Notice of Allowability	Application No.	Applicant(s)
	10/700,703	HANKS, D'ANNE BEUKELAER
	Examiner Jinhee J. Lee	Art Unit 2831

EXAMINER'S AMENDMENT

Approved Proposed Drawing
JWL 4/14/05

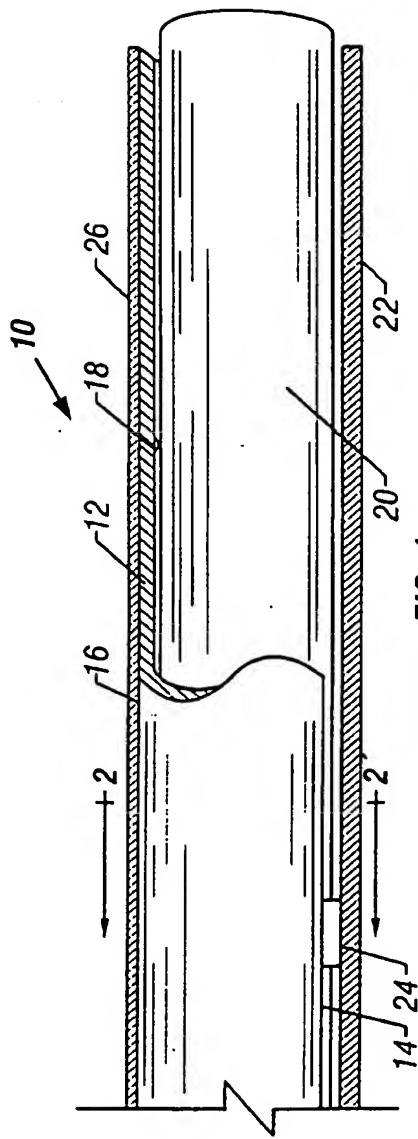
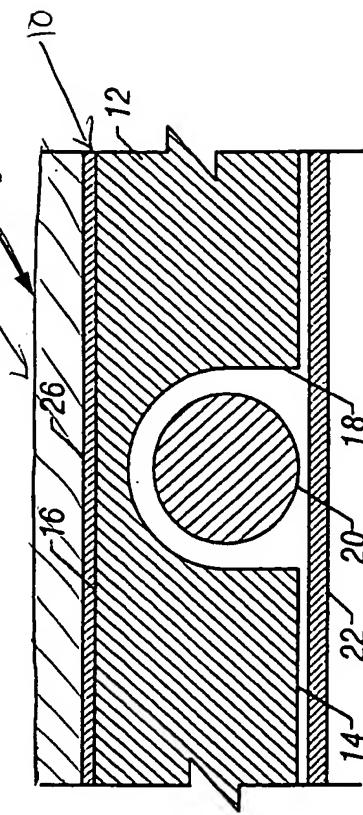
4. Add Chassis on drawing as shown in proposed drawings attached.

5. Add the item number to the Chassis added to the proposed drawing attached.
